October 25, 2010

John Boccio
Public Utilities Regulatory Analyst IV
California Public Utilities Commission (CPUC)
505 Van Ness Avenue
San Francisco, California 94102

Subject: California Condor and other Listed Species at the Manzana (Formerly PdV)
Wind Project

Figure 2. Project Boundary Compared to Wind Energy Zoning

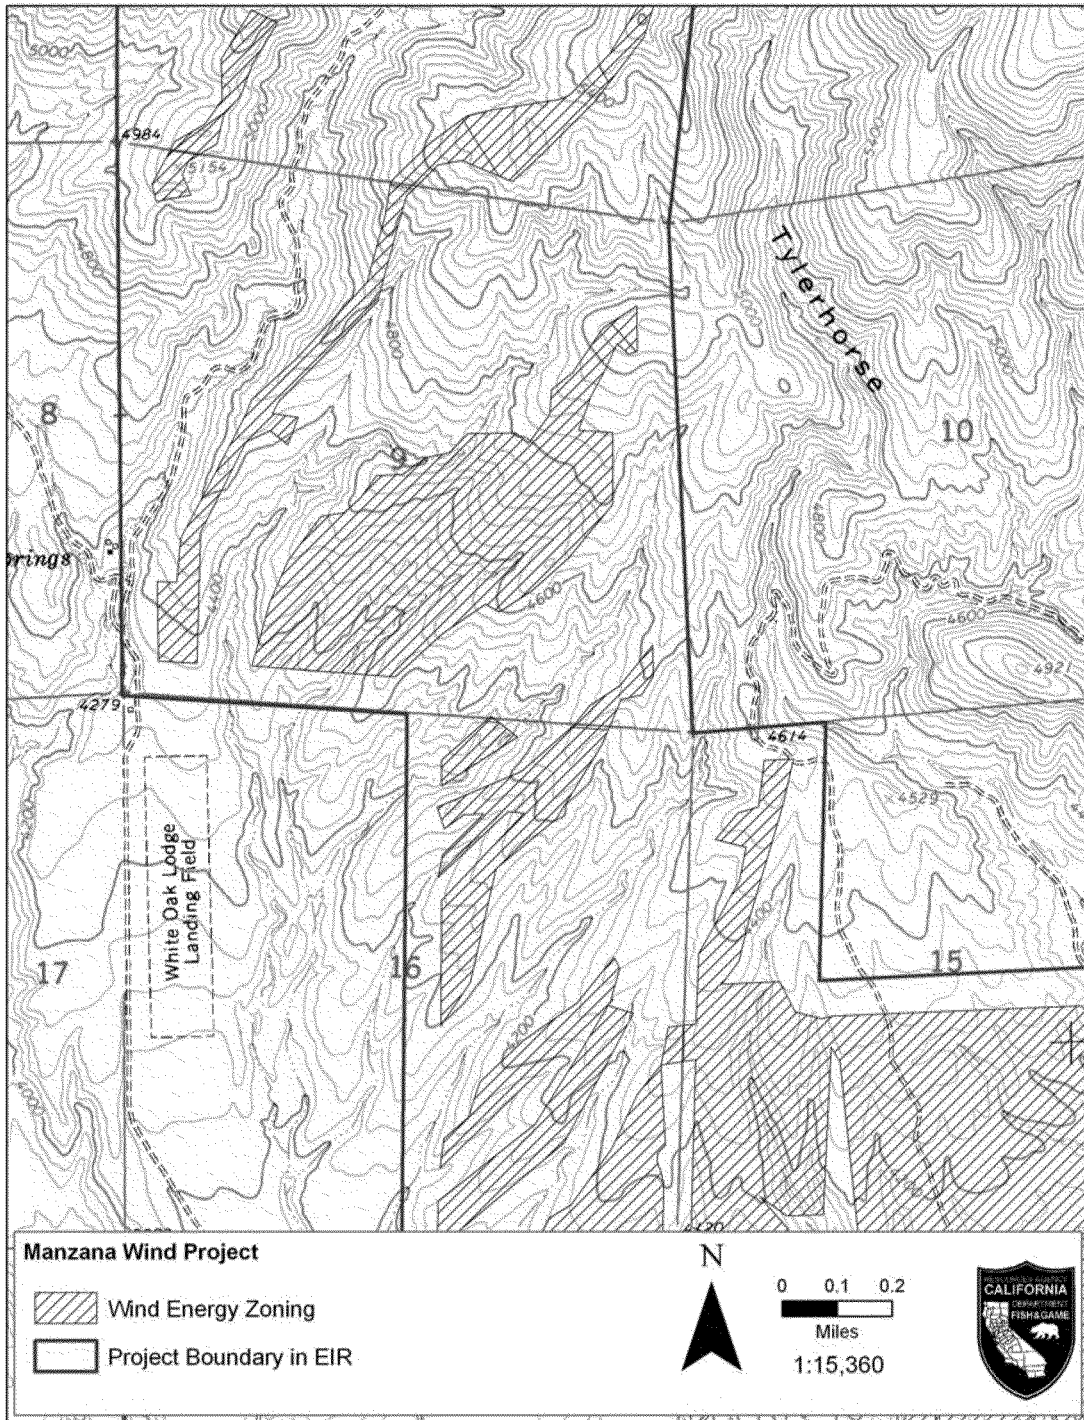
- 3. Definition of Project Limits.** Kern County staff have asserted to the Department on similar projects that their CEQA authority extends only to the areas where they are changing zoning classification to allow wind development. On this Project site, the zoning change was applied only to the turbine row locations instead of the entirety of the affected parcels. Figure 2

shows the northern part of the Project as an example of how the wind energy zoning classification does not conform to parcel boundaries or the "Project Boundaries" as depicted in the EIR and Addendum. The Department is unclear on the County's intention or ability to enforce the EIR measures beyond the area zoned for wind energy. Similarly, we are unclear on whether by adopting the County's EIR and Addendum, the CPUC would be limited to enforcing the mitigation measures only within the areas zoned for wind energy. Regardless, if the applicant's lease applies only to the footprint of the facilities as described in item #2 above, then the applicant would not have the ability to assure implementation of the mitigation measures across most of the Project site as mapped in the EIR.
